MFN 08-851

**Response to Portion of NRC Request for
Additional Information Letter No. 259
Related to ESBWR Design Certification Application**

RAI Numbers 6.2-198 and 6.2-199

DCD Markups

Figure 6.2-29. CIS Simplified System Diagram

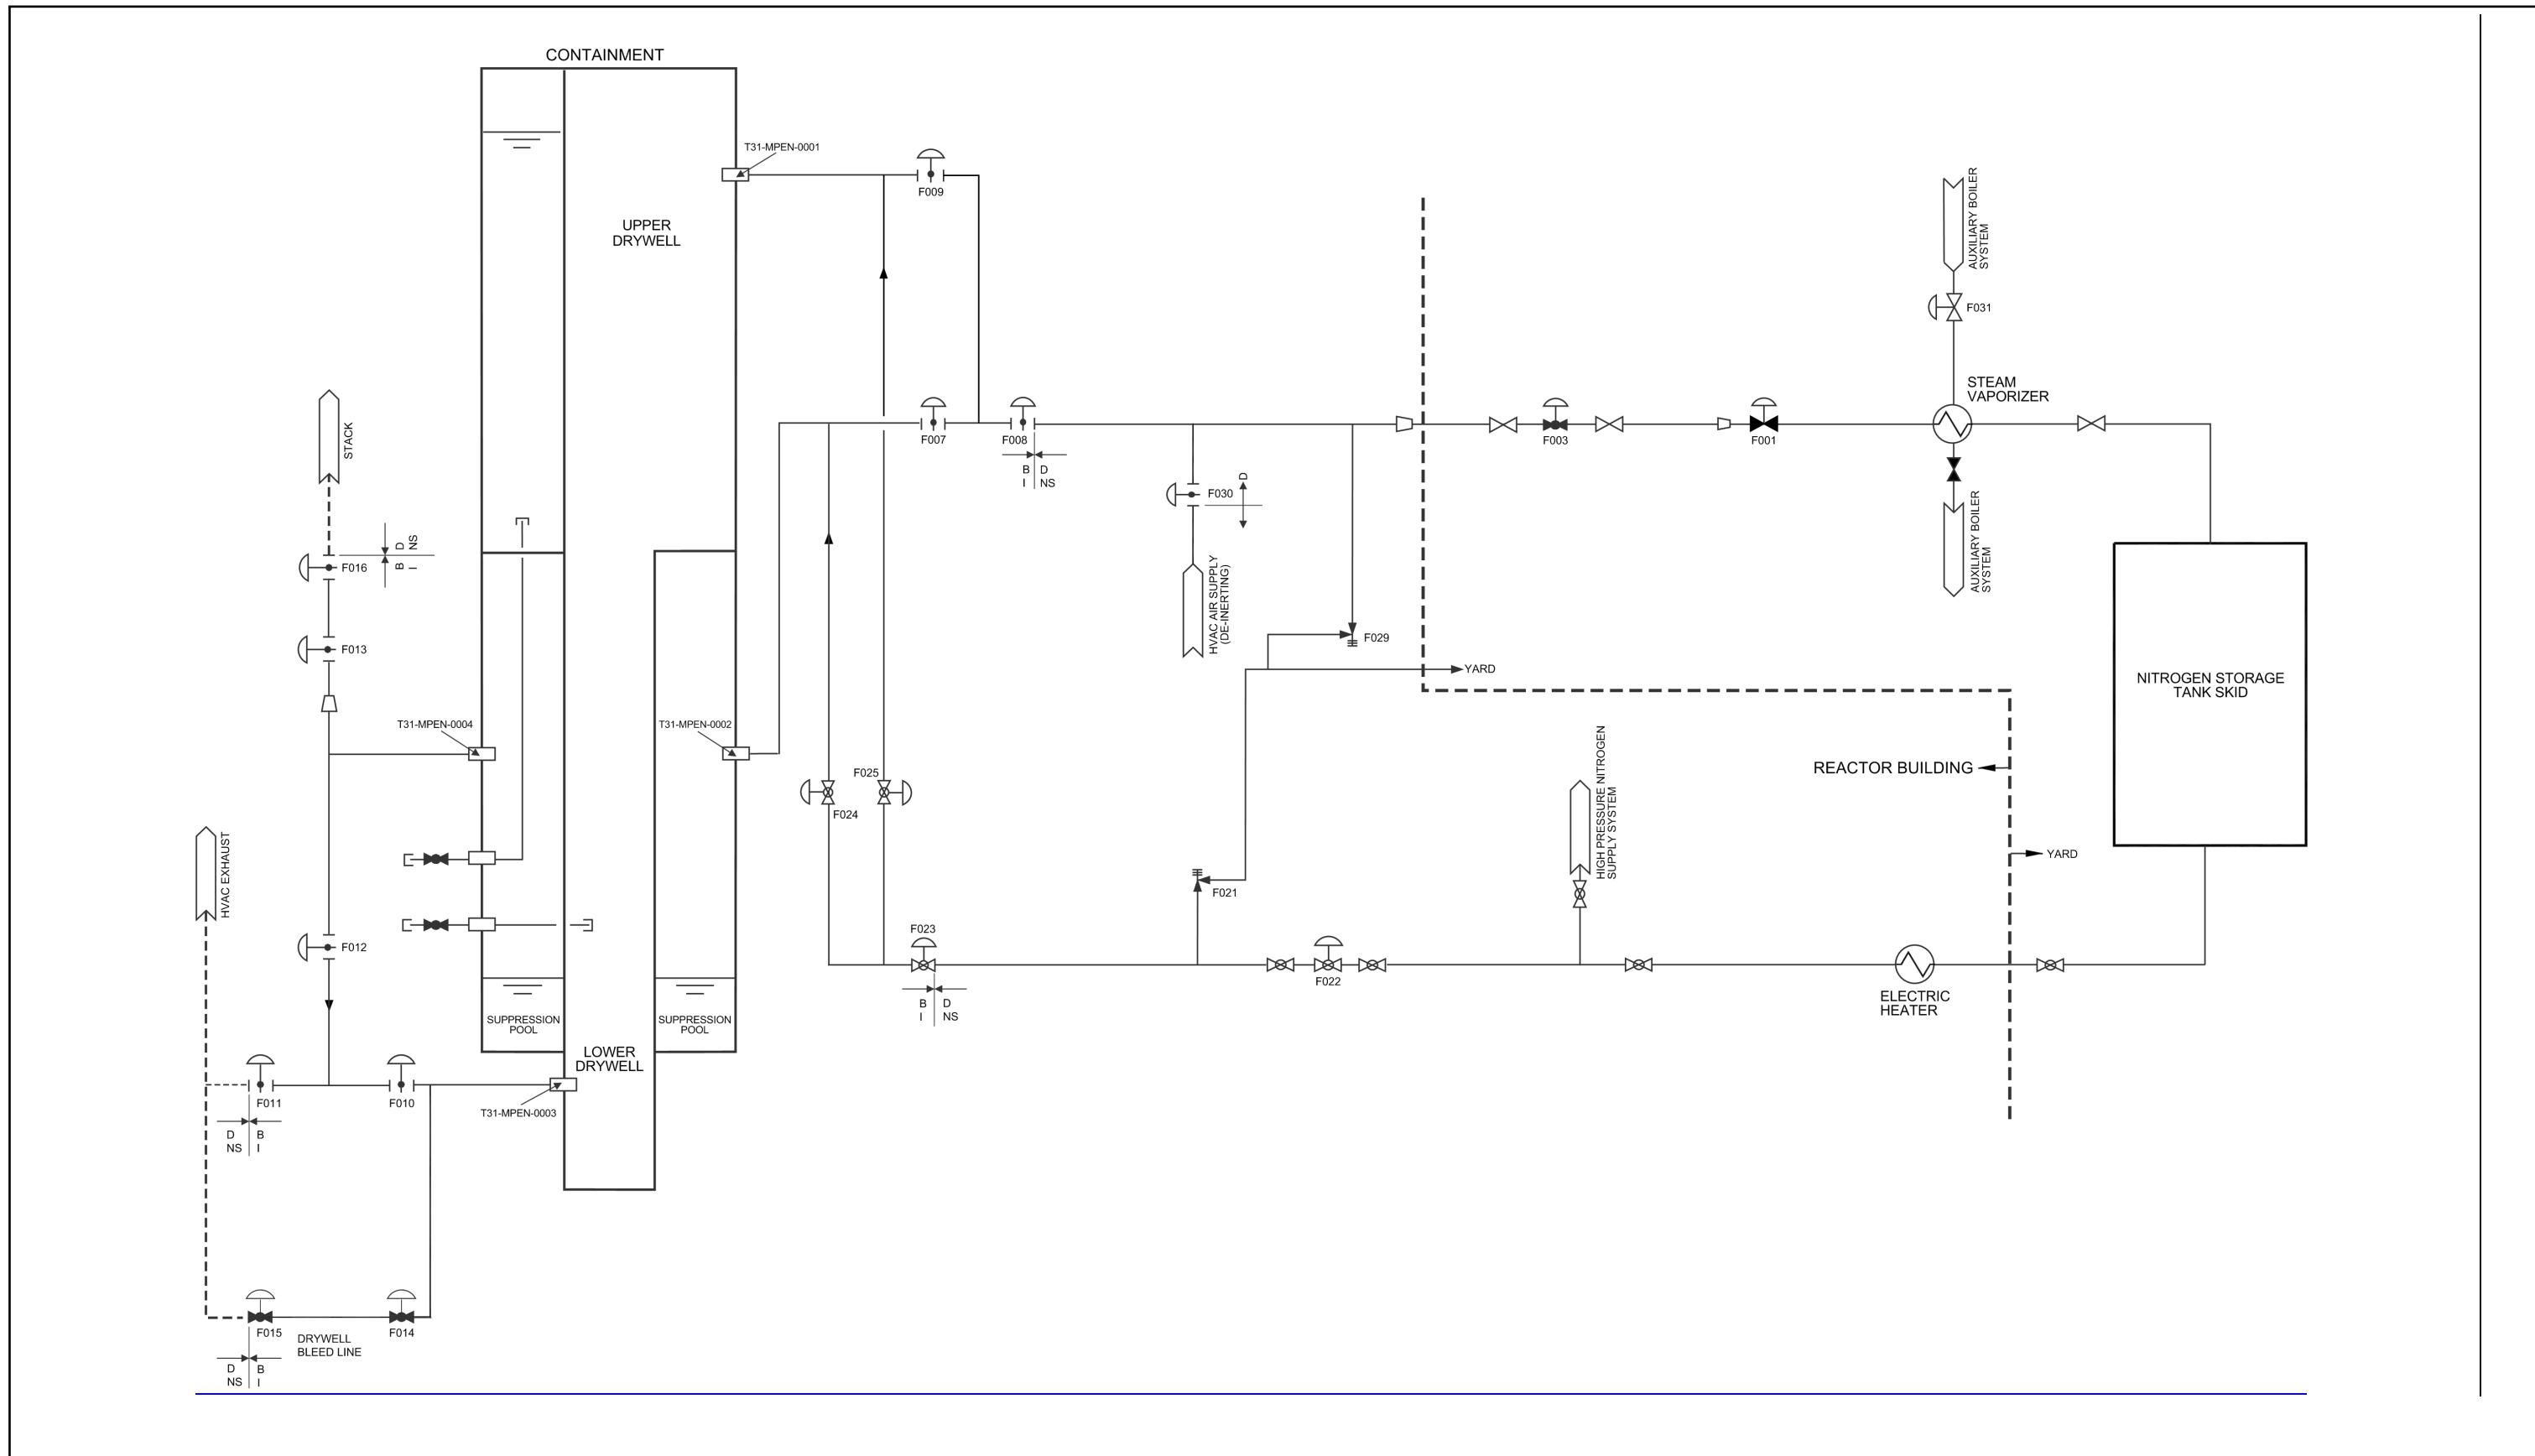
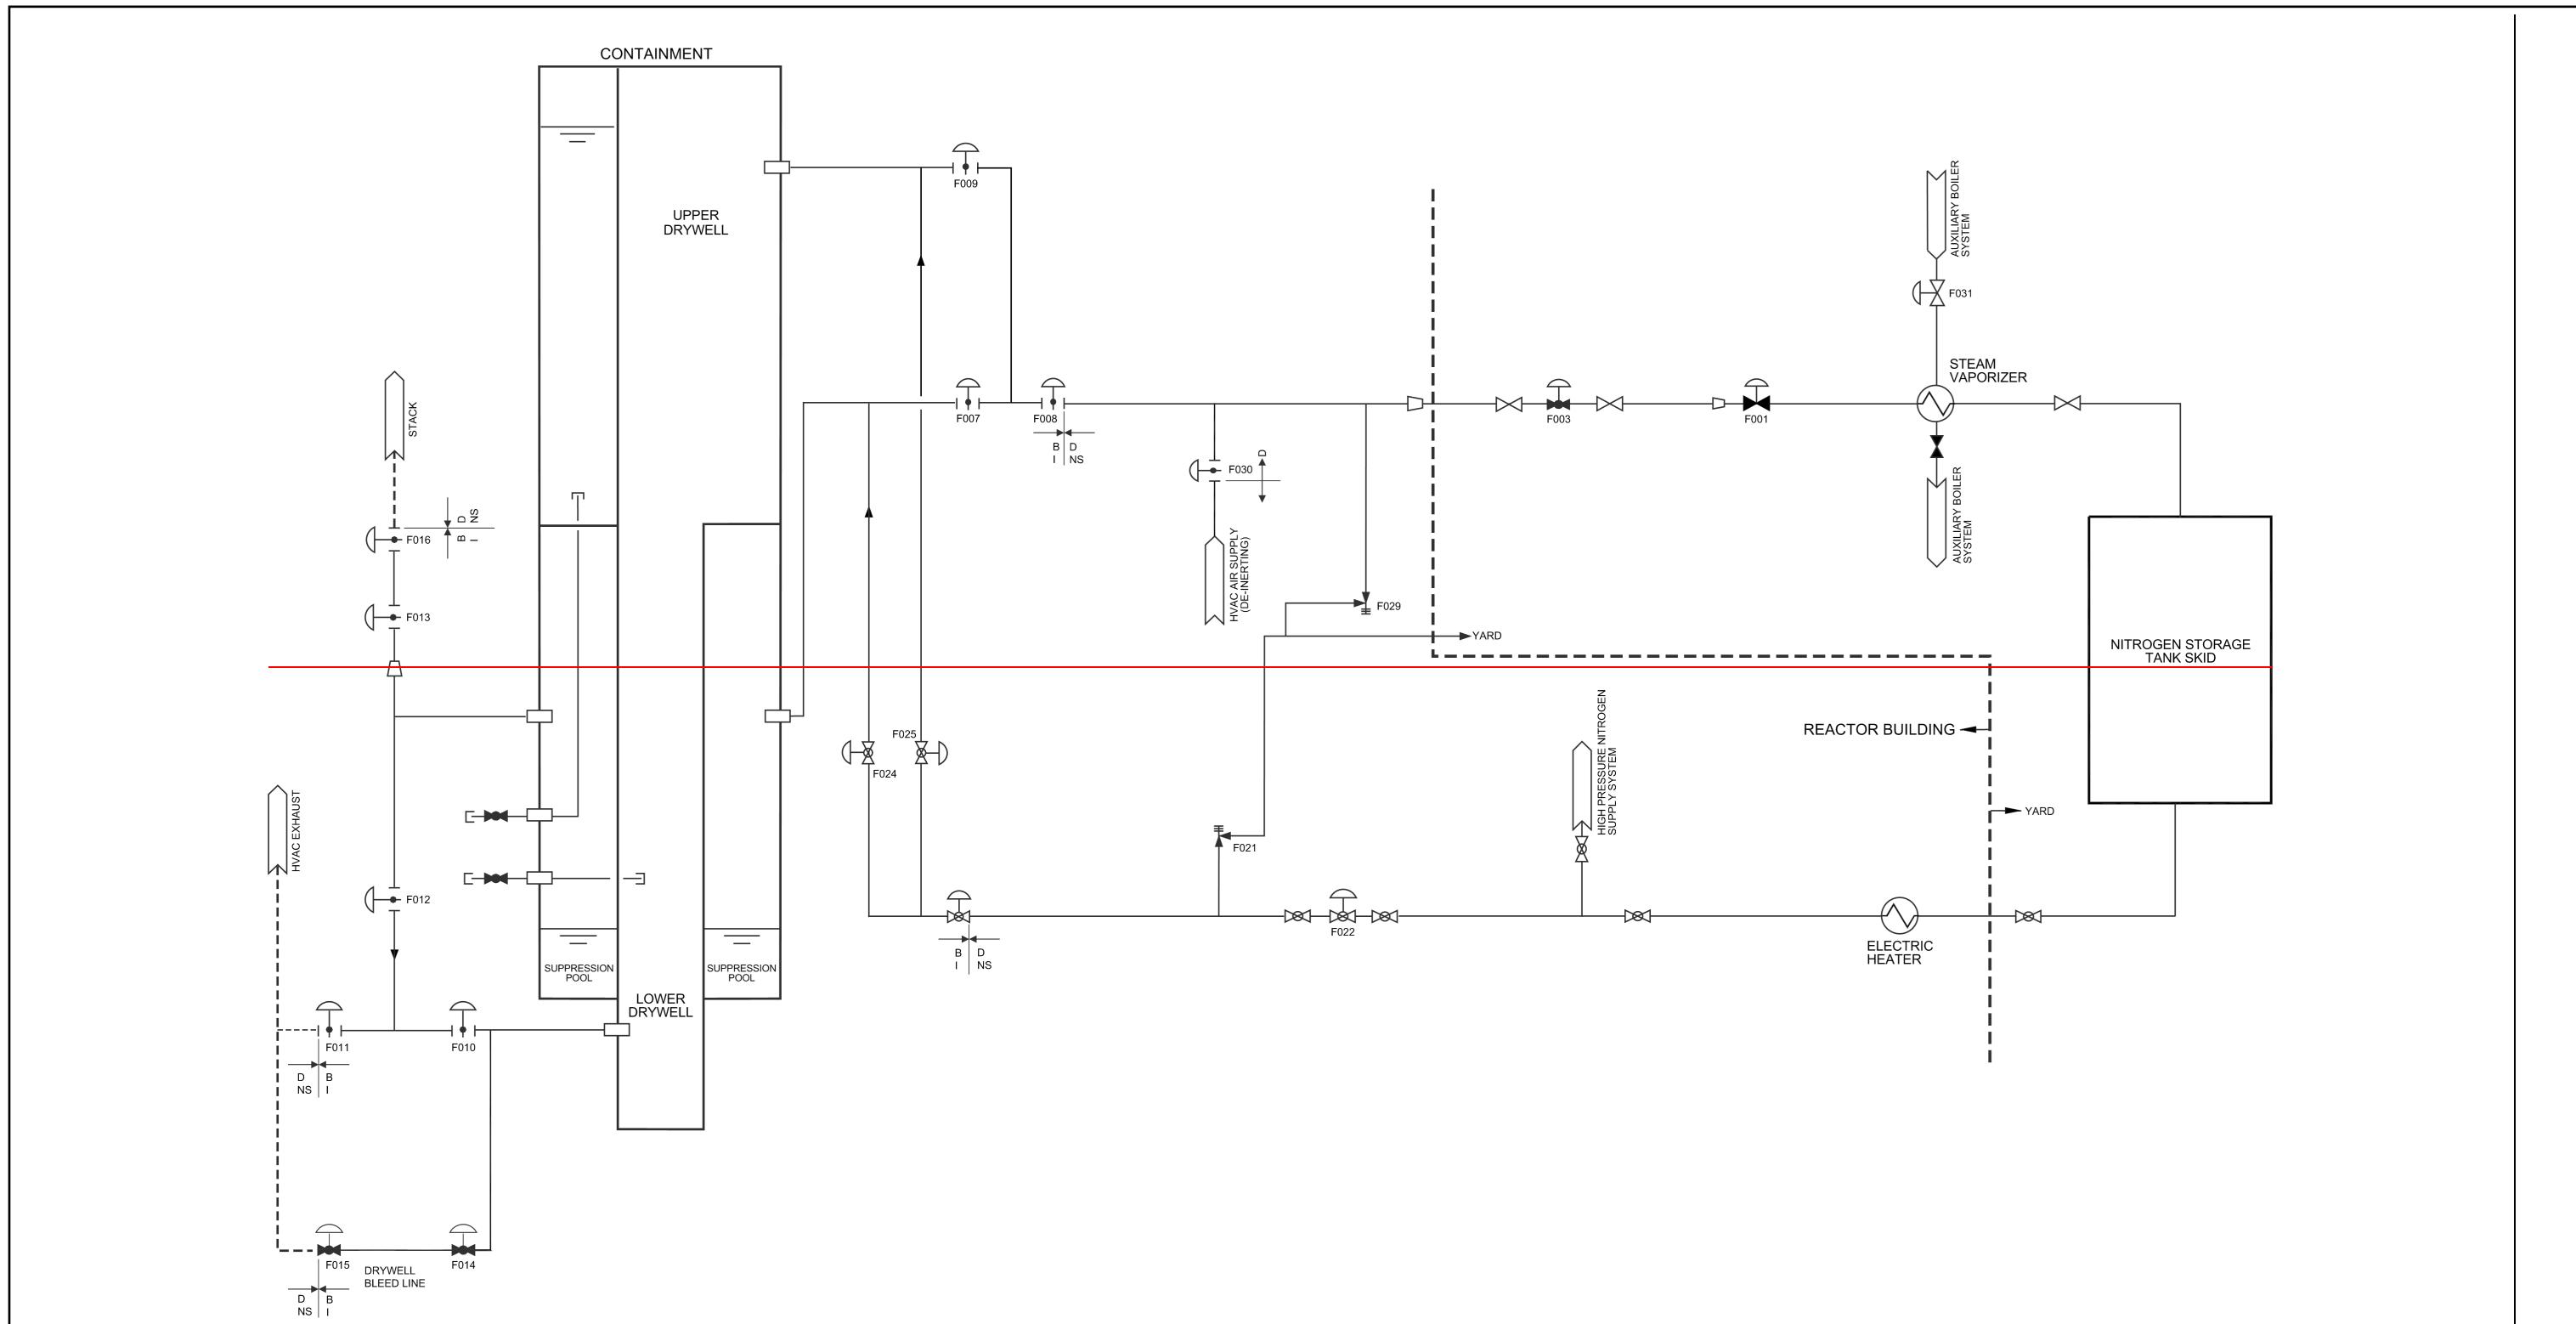
The penetration of the Containment Inerting System consists of two tandem quarter-turn shutoff valves (normally closed) in parallel with tandem stop or shutoff valves. All isolation valves on these lines are outside of the containment so that they are not exposed to the harsh environment of the wet well and dry well and are accessible for maintenance, inspection and testing during reactor operation. Both containment isolation valves are located as close as practical to the containment. The valve nearest to the containment is provided with a capability of detection and termination of a leak. The piping between the containment and the first isolation valve and the piping between the two isolation valves are designed as per requirements of SRP 3.6.2. These piping are also designed to:

Penetration Identification		T31-MPEN-0002*		
Valve No.	F008	F007	F024	F023
Applicable Basis	GDC 56	GDC 56	GDC 56	GDC 56
Tier 2 Figure	<u>6.2-29</u> <u>9.4-14</u>	<u>6.2-29</u> <u>9.4-14</u>	<u>6.2-29</u> <u>9.4-14</u>	<u>6.2-29</u> <u>9.4-14</u>
ESF	No	No	No	No
Fluid	Air/N ₂	Air/N ₂	Air/N ₂	Air/N ₂
Line Size ⁺	500 mm (20 in)	350 mm (14 in)	25 mm (1 in)	25 mm (1 in)
Type C Leakage Test	Yes	Yes	Yes	Yes
(Deleted) Pipe Length from Cont. to Inboard/Outboard Isolation Valve	COL Holder to provide			
Leakage Through Packing ^(a)	a ₁	a ₁	a ₁	a ₁
Leakage Past Seat ^(b)	b ₂	b ₂	b ₂	b ₂
Location	Outboard	Outboard	Outboard	Outboard
Valve Type	QBF, QBL	QBF, QBL	QBL, QBF	QBL, QBF
Operator ^(c)	AO	AO	AO	AO
Normal Position	Closed	Closed	Open	Open
Shutdown Position	Open	Open	Closed	Closed
Post-Acc Position	Closed	Closed	Closed	Closed
Power Fail Position	Closed	Closed	Closed	Closed
Cont. Iso. Signal ^(d)	B,C,H,T	B,C,H,T	B,C,H,T	B,C,H,T

Penetration Identification		T31-MPEN-0001*		
Valve No.	F025	F023	F008	F009
Applicable Basis	GDC 56	GDC 56	GDC 56	GDC 56
Tier 2 Figure	<u>6.2-29</u> 9.4-14	<u>6.2-29</u> 9.4-14	<u>6.2-29</u> 9.4-14	<u>6.2-29</u> 9.4-14
ESF	No	No	No	No
Fluid	Air/N ₂	Air/N ₂	Air/N ₂	Air/N ₂
Line Size ⁺	25 mm (1 in)	25 mm (1 in)	500 mm (20 in)	350 mm (14 in)
Type C Leakage Test	Yes	Yes	Yes	Yes
(Deleted) Pipe Length from Cont. to Inboard/Outboard Isolation Valve	COL Holder to provide			
Leakage Through Packing ^(a)	a ₁	a ₁	a ₁	a ₁
Leakage Past Seat ^(b)	b ₂	b ₂	b ₂	b ₂
Location	Outboard	Outboard	Outboard	Outboard
Valve Type	QBL, QBF	QBL, QBF	QBF, QBL	QBF, QBL
Operator ^(c)	AO	AO	AO	AO
Normal Position	Open	Open	Closed	Closed
Shutdown Position	Closed	Closed	Open	Open
Post-Acc Position	Closed	Closed	Closed	Closed
Power Fail Position	Closed	Closed	Closed	Closed
Cont. Iso. Signal ^(d)	B,C,H,T	B,C,H,T	B,C,H,T	B,C,H,T
Primary Actuation	Automatic	Automatic	Automatic	Automatic
